RE: Drainage plan Southerly portion of the Shores development

RE: Morris Manor (formerly called The Shores) and the existing The Shores
planned residential development.

RE: Drainage Report for "The Shores" Addition

Subject: Drainage Report for "The Shores" Subdivision

THE SHORES SUBDIVISION
(UNDEVELOPED TRACT)-
GRADING PLAN FOR TYPICAL HOUSE LOT
SCALE: 1" = 20'

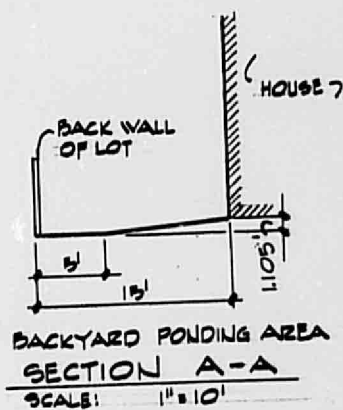
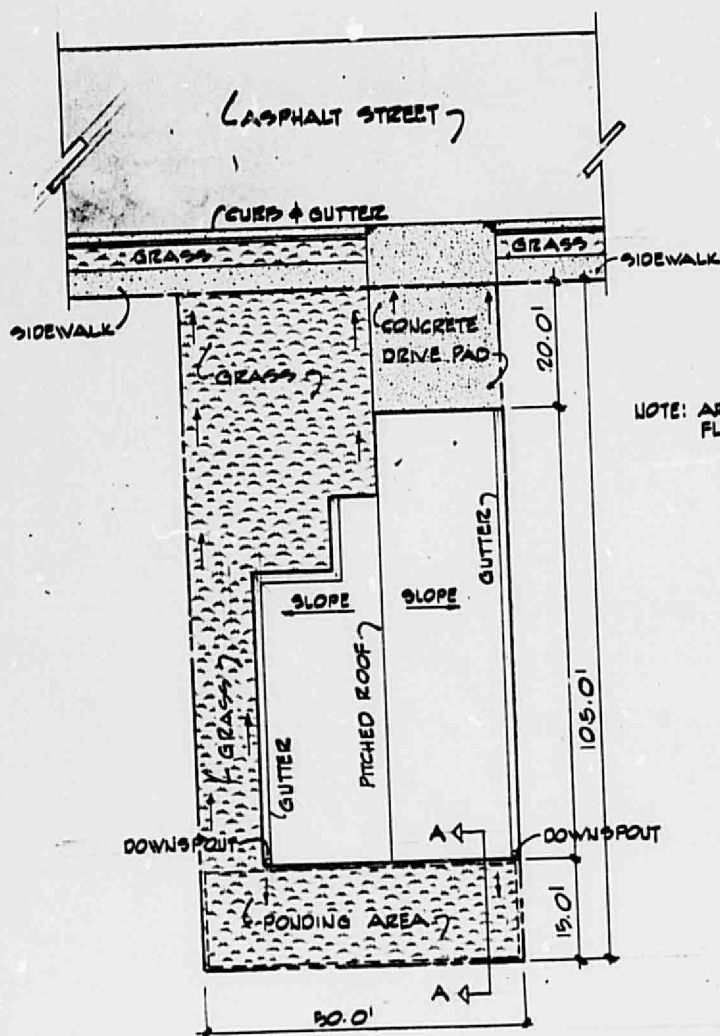
Regarding the question of backyard ponding, an error is noted on page A-3. The surface of the ponding areas is indicated in 72000 sq. ft. while all the previous computations reported a surface area of 32000 sq. ft. Correspondingly, the depth of ponding should be 15.2 in. instead of the indicated 11.0 in.

Due to a lack of coordination on our part some revisions in our drainage report
calculations failed to be included in the final draft of our report. Thus,
we are enclosing corrected copies of pages 4, A-2, A-3, and FIGURE 1. We have
also incorporated in these revised calculations, the following revised values
in order to comply with your recently promulgated STANDARD REQUIREMENTS FOR
DRAINAGE PLANS:

As is shown on revised page A-3 and FIGURE 1, the recomputed depth of ponding is 13.26 inches or 1.105 feet.

$$h = 1.105 \text{ ft.} \cdot \frac{12 \text{ in.}}{1 \text{ ft.}} = 13.26 \text{ inches}$$

FIGURE 1

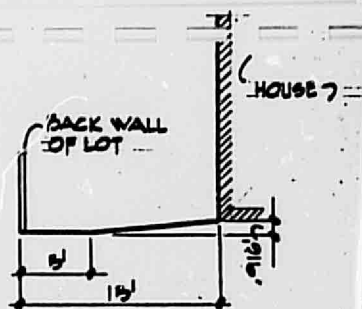
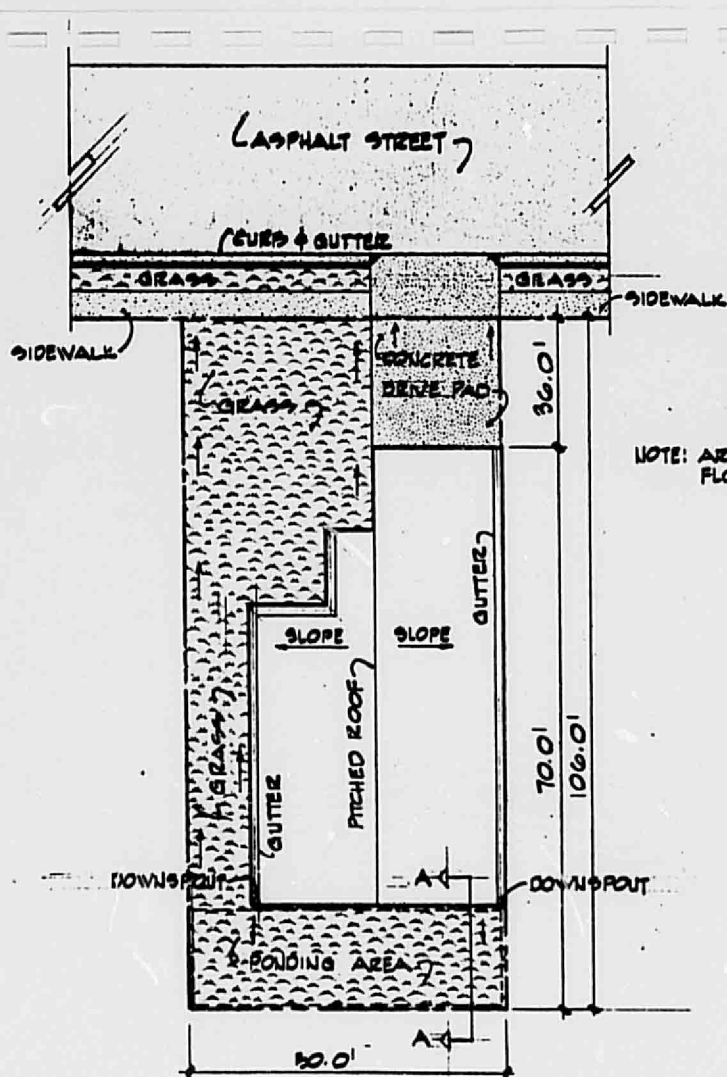
Regarding the question of backyard ponding, an error is noted on page A-3. The surface of the ponding areas is indicated in 72000 sq. ft. while all the previous computations reported a surface area of 32000 sq. ft. Correspondingly, the depth of ponding should be 15.2 in. instead of the indicated 11.0 in.

As is shown on revised page A-3 and FIGURE 1, the recomputed depth of ponding is 13.26 inches or 1.105 feet.
